**Avnet MiniZed**  
**Revision 1 Errata**  
**V1.0**  
**12 December 2017**

#### 3.1 Remote JTAG Debug Reset Does not Work

Figure 2 – Missing Resistors on the Rev 1 MiniZedZed Design

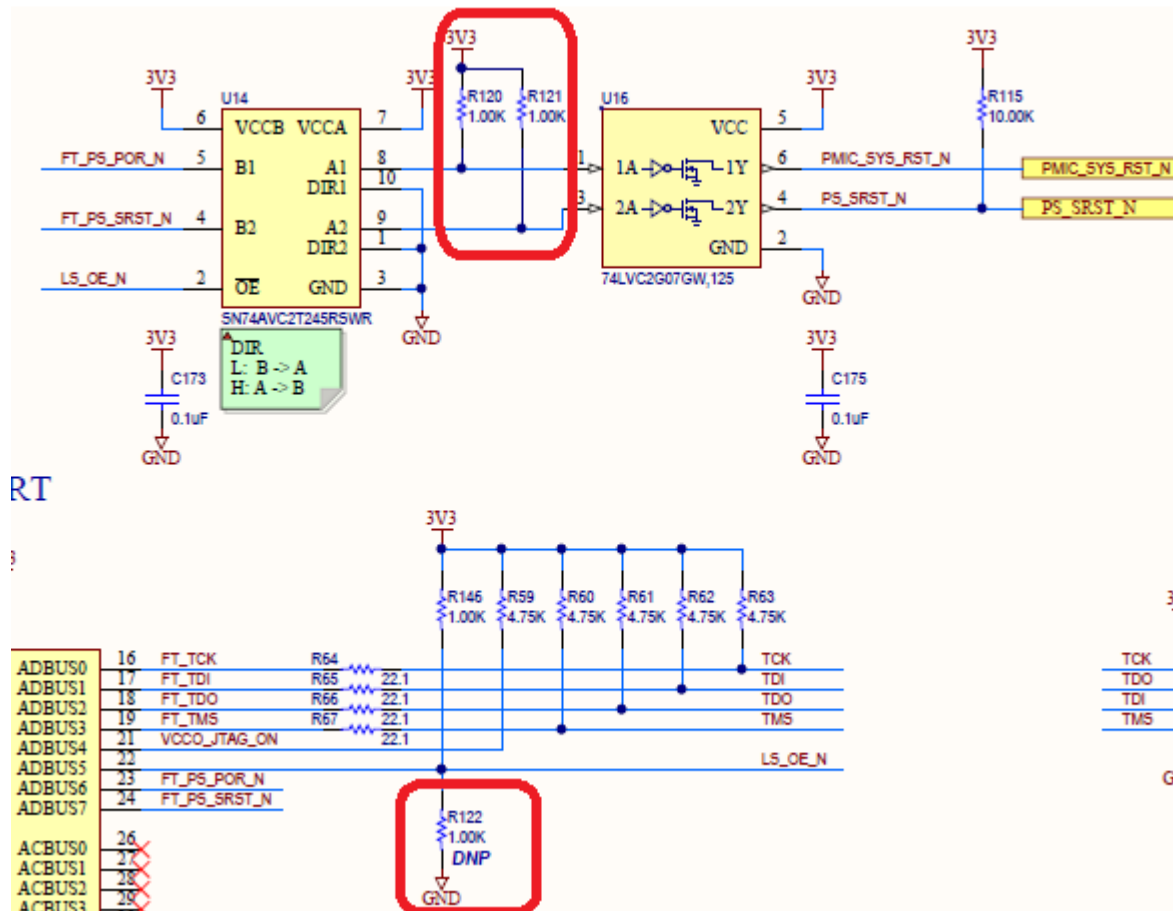
The resistors marked in red below are not on the current schematic. This is due to a design oversight, since they should have been included. Without them, it was discovered that many boards manifested an unreliable reset on power-up. This was because the inputs to U16 would float when the FTDI chip was not actively driving the LS\_OE\_N line. Because this line is under software control via the FTDI driver, it is not driven unless debug software is active.

**Figure 3 – U16 Removed on Current Rev 1 MiniZedZed Schematic**

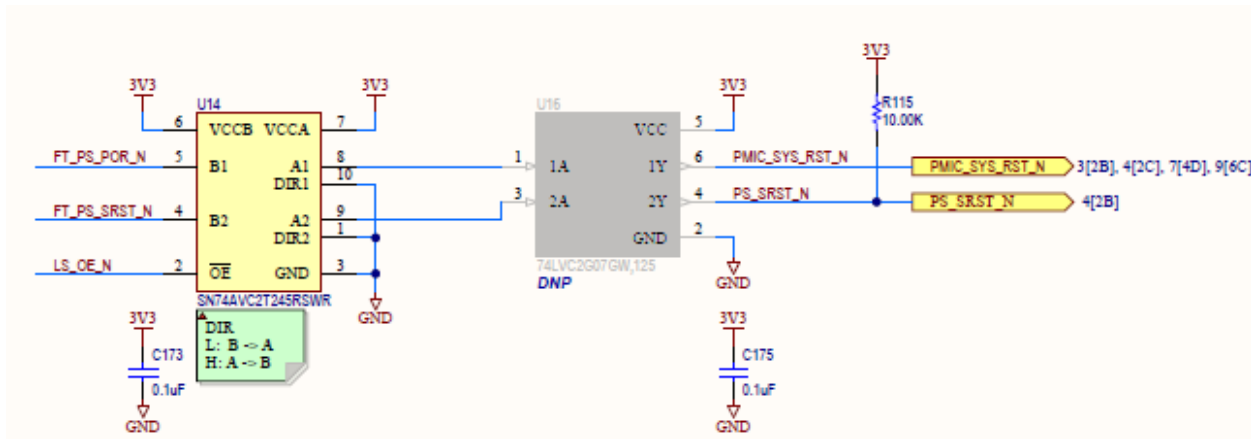
The solution (shown in the image below) was to remove U16 on the Rev 1 boards. This causes power-on reset to be reliable, but unfortunately a software reset via the JTAG driver software is not supported anymore.

Note that U16 was not removed from all Rev A prototype boards (with a red PCB). So these boards will manifest unreliable reset, but software reset will work.

**Figure 4 – Modification to pull LS\_OE\_N Low**

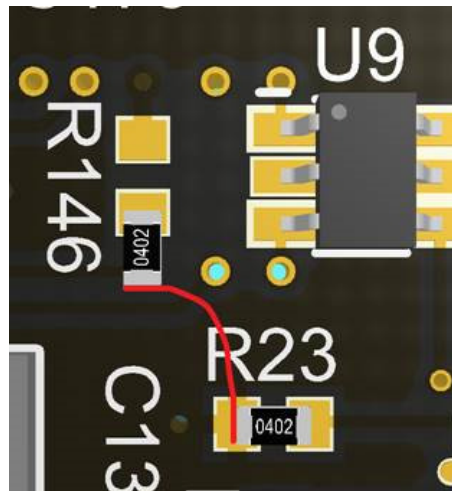
The replacement of U16 will cause software reset to work, but power-on reset to be unreliable. This is because LS\_OE\_N could be high during power-up, which would result in U16's inputs floating. If LS\_OE\_N is pulled low though, this could be remedied. This can be accomplished by desoldering R146 (1K) and then using a jump-wire to connect it to GND on R23, as shown in the image below.

If you simply wanted to test the remote debug feature to make sure how it would work on your own custom hardware design, you could replace U16, which is a 74LVC2G07GW,125 device from NXP with description: IC BUFFER N-INV OP/DRAIN 6TSSOP.
